Queries regarding the bid document from the bidders.

Karnali Solar Energy Project

Guard House
Plans, Elevations, Section &
Slab design

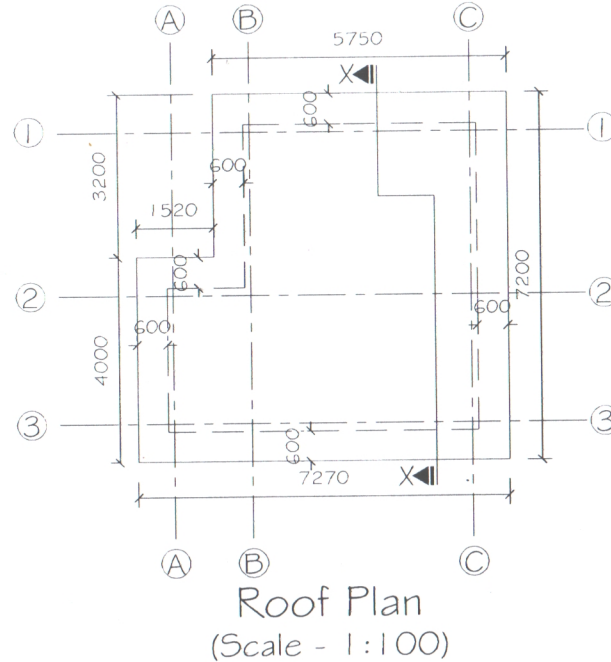
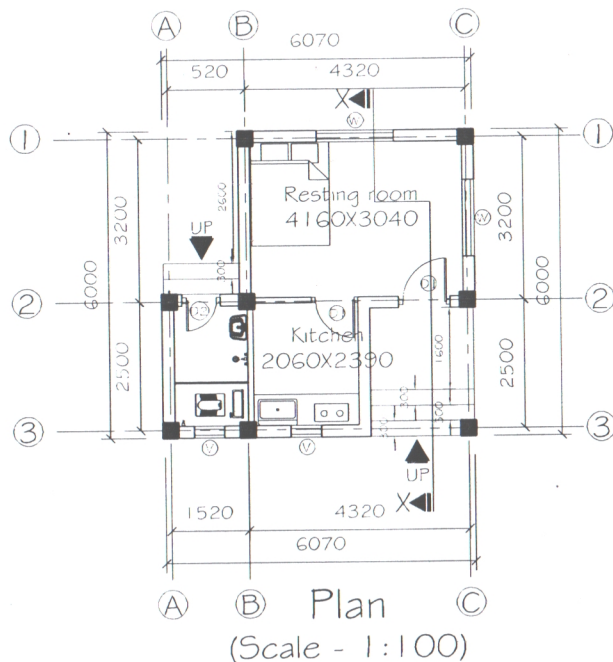
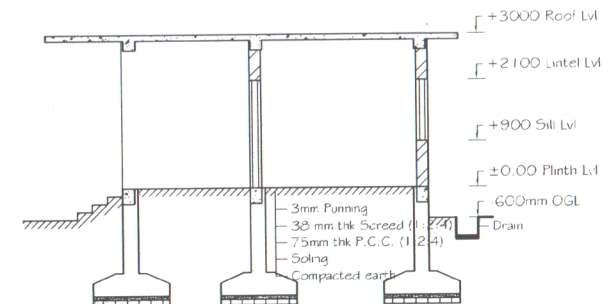
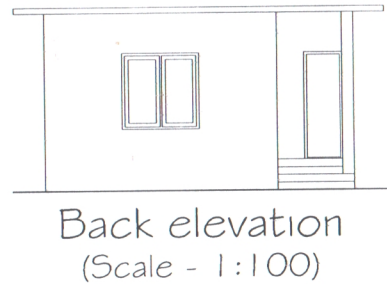
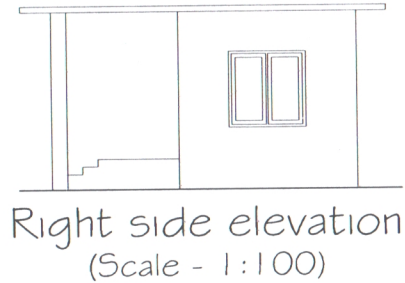
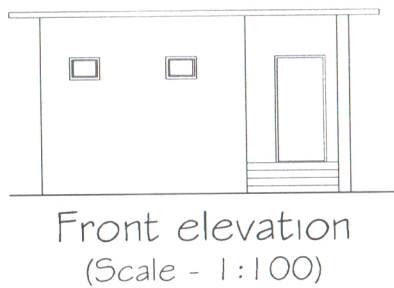
99		<p>Please provide drawings for guard house as stated in BOQ 4(a) 7.01</p>	<p>Please find attached the drawings for guard house and boundary wall</p>
